UNITED STATES PATENT AND TRADEMARK OFFICE

10/849,263

Office Action Summary

DETAILED ACTION

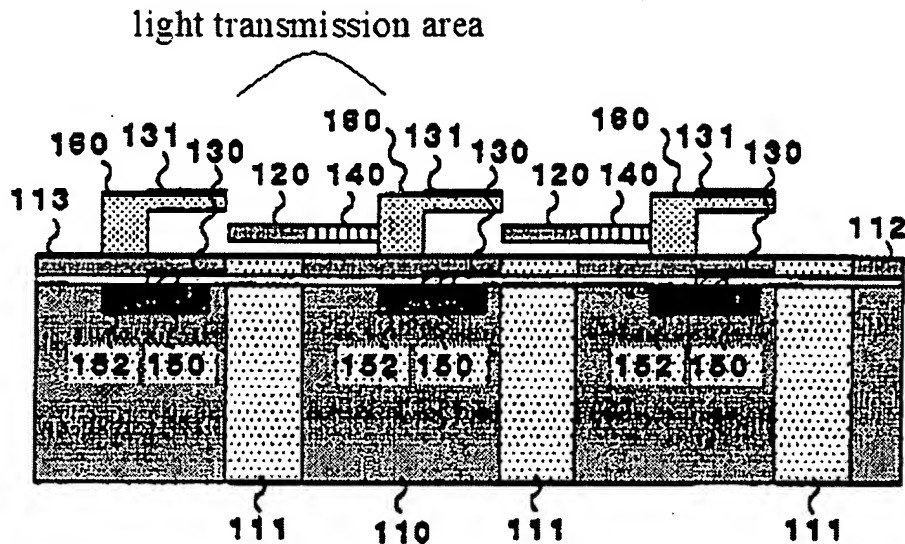
a) Within respect to claim 1, Koehler et al. discloses an electrostatically actuatable light modulating device in Figure 4 comprising of a light transmission area (see below Figure) a transparent substrate (item 110); a pixel drive circuit provided on the transparent substrate (items 150, 152) to form an area other area than the light-transmission area, a transmissive light modulation section including a micro-electromechanical element (item 12), the transmissive light modulation section being controlled by the pixel drive circuit (150, 152) and being provided above the pixel drive circuit (col.2,line 3 - col.3,line 8).

b) Within respect to claims 3, 5 and 7, Koehler et al. discloses an electrostatically actuatable light modulating device in Figure 4 and further with method comprising of a first silicon layer (item 110), an insulation layer (item 130) and a second silicon layer (item 112) in this order, the method comprising: forming a pixel drive circuit (item 150, 152) on the insulation layer (130), the pixel drive circuit including at least part of the second silicon layer (112); eliminating the first silicon layer while a portion other than the first silicon layer is supported; attaching a transparent substrate to the location from which the first silicon layer was removed; and forming a transparent light modulation section including a micro-electromechanical element above the pixel drive circuit (col.2,line 3 - col.3,line 8).

Koehler et al. discloses an electrostatically actuatable light modulating device in Figure 4 comprising of a light transmission area (see below Figure) a transparent substrate (item 110); a pixel drive circuit provided on the transparent substrate (items 150, 152) to form an area other area than the light-transmission area, a transmissive light modulation section including a micro-electromechanical element (item 12), the transmissive light modulation section being controlled by the pixel drive circuit (150, 152) and being provided above the pixel drive circuit (col.2,line 3 - col.3,line 8).

Koehler et al. does not teach a microlens array provided at an entrance side. Within the same field of endeavor, Johnson disclose a Multi-stage microlens array with teaching of microlens at the entrane side of the transmissive area (Fig. 5A)
